TITLE: Fire Sprinkler Insulation in Attic
PROJECT: Downtown Senior Services Center

SENIOR SERVICES CENTER
300 & 310 SOUTH 9TH STREET
LAS VEGAS, NV 89101
FIRE SPRINKLER PLAN

PROJECT NUMBER	S0435
SHEET NUMBER	FS-2

FLOOR PLAN

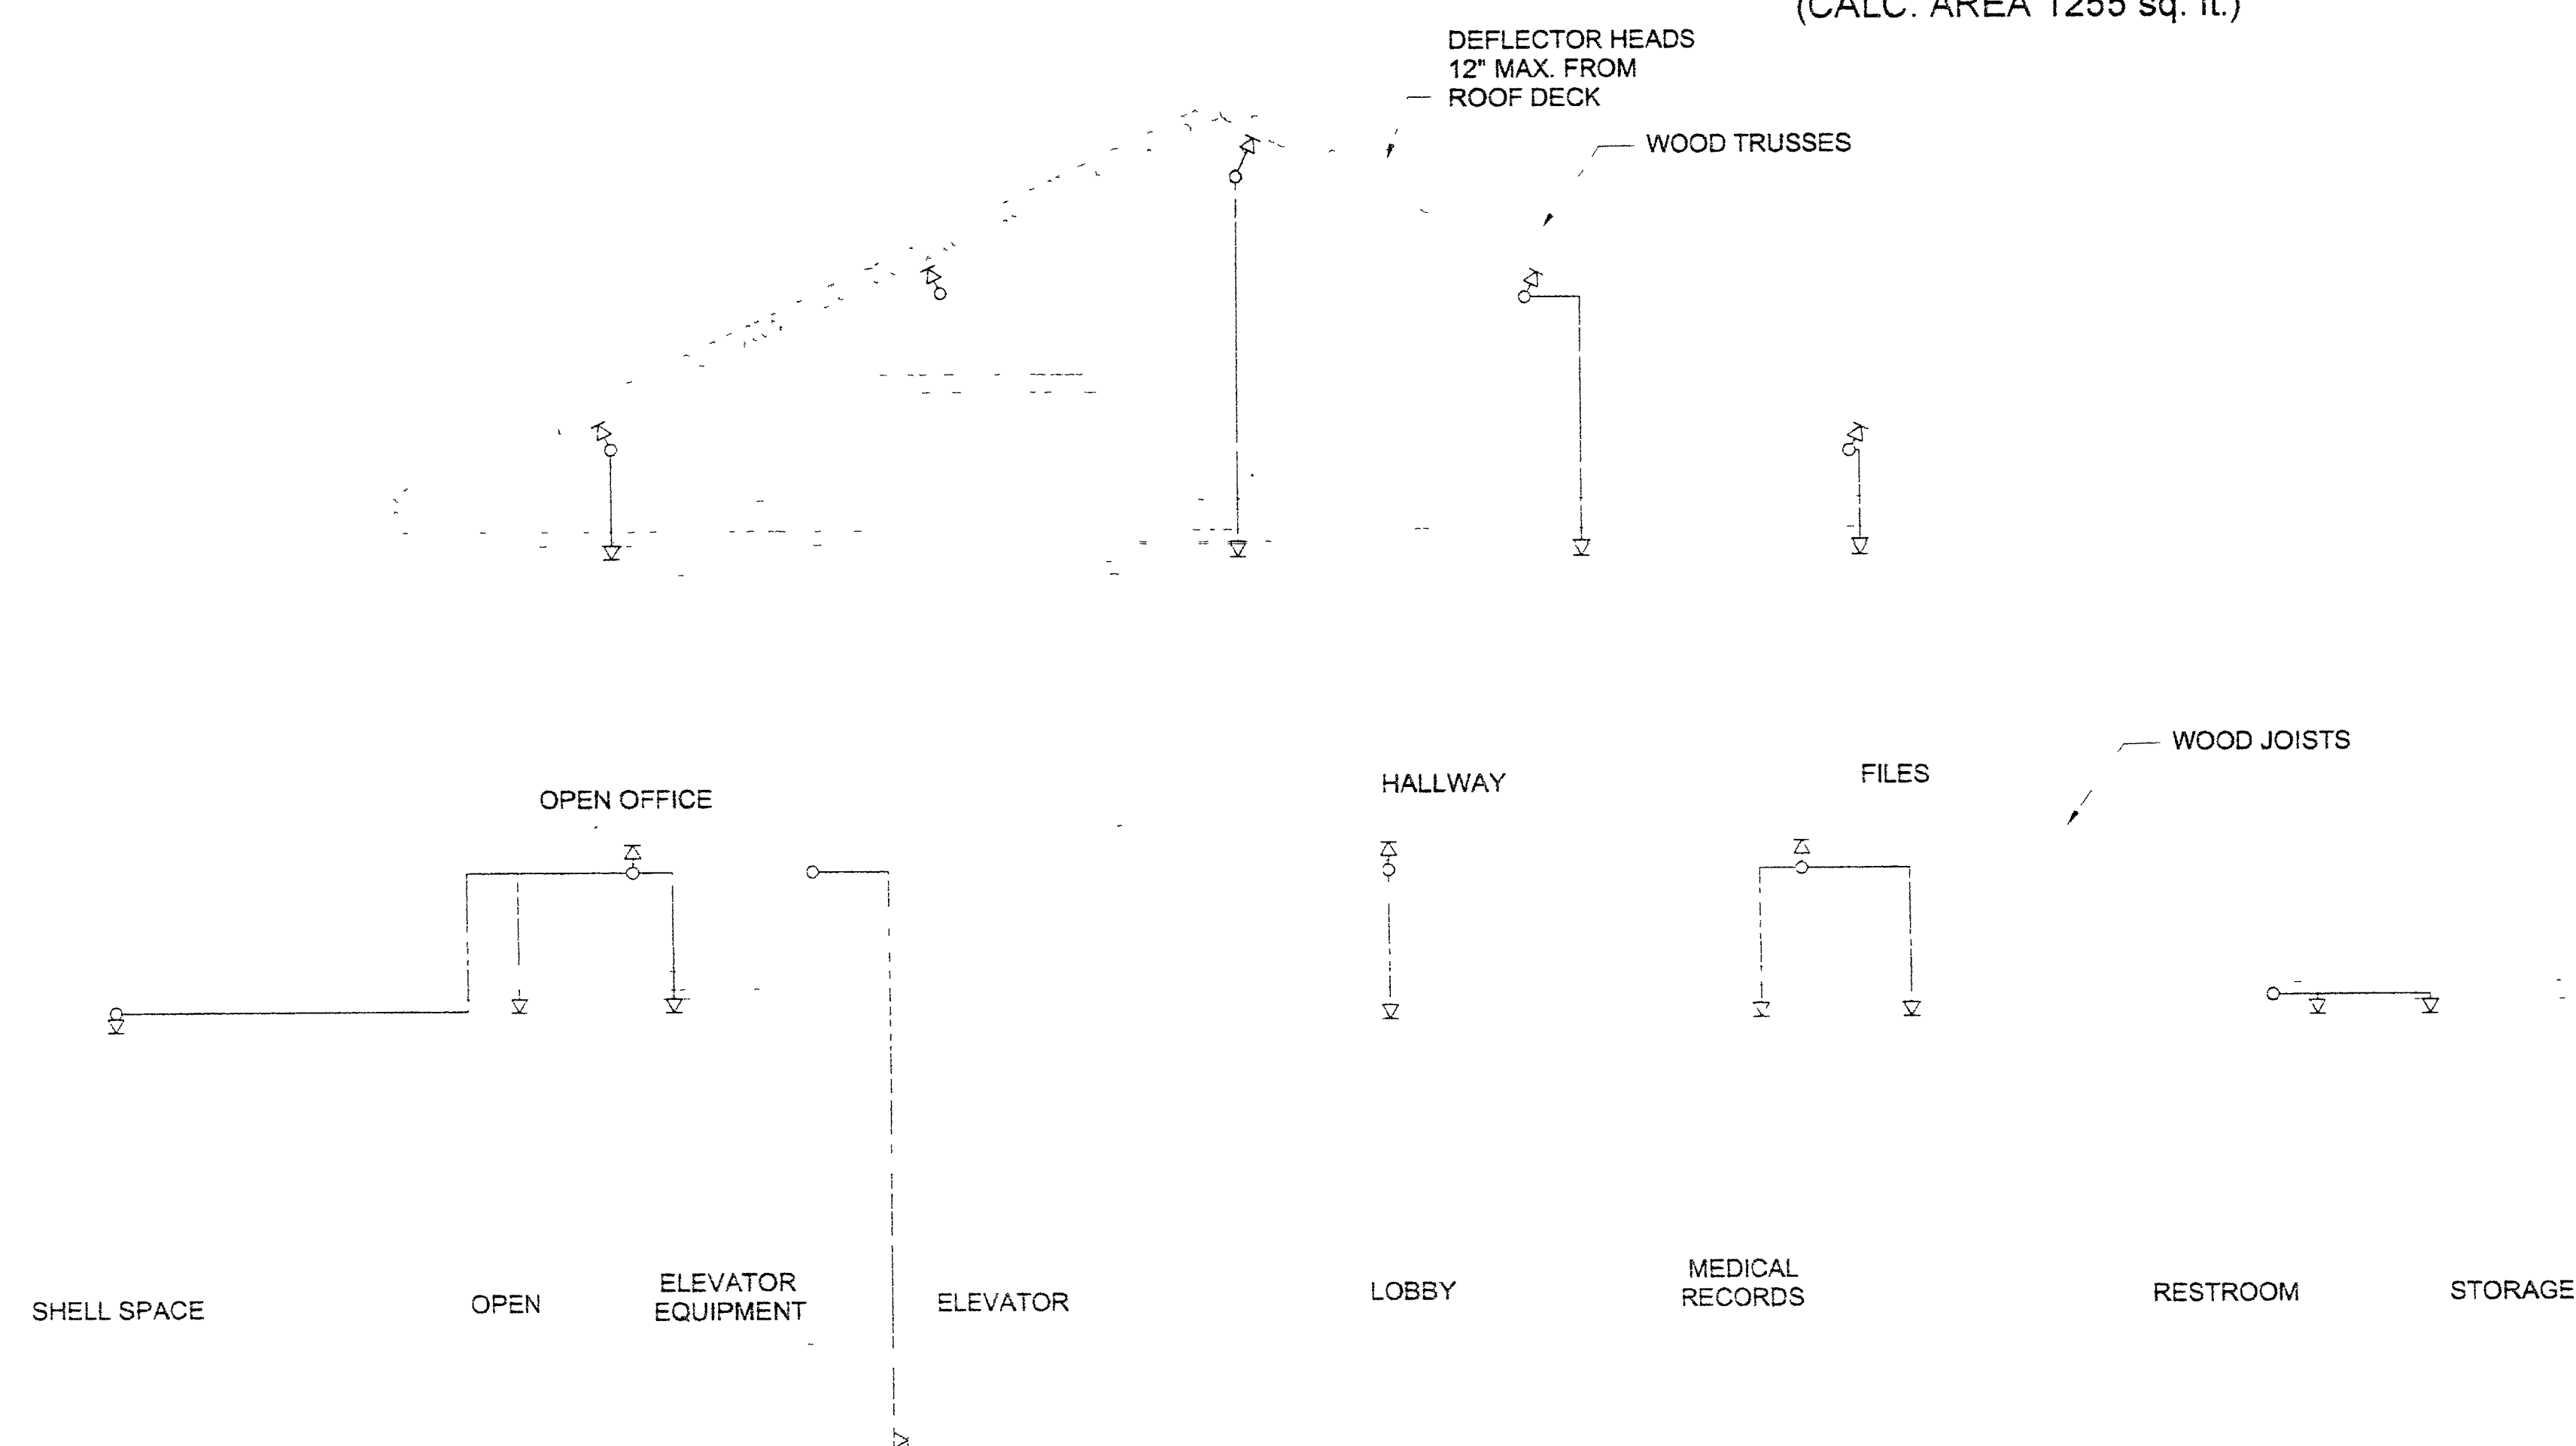
RFI	CLV	RCI	00005	ACEFR	Sp Pipe @ Drag Strut	CLO	4/20/2005	4/26/2005	4/27/2005
					Please advise if a hole for 2" pipe can be drilled in the glue lam of the new drag strut for the routing of the sprinkler piping in building R2		Per JMA 4/21/05 Per Wright Engineers		
							Provided 2" hole is placed 1-1/2" minimum below drag straps, hole is acceptable.
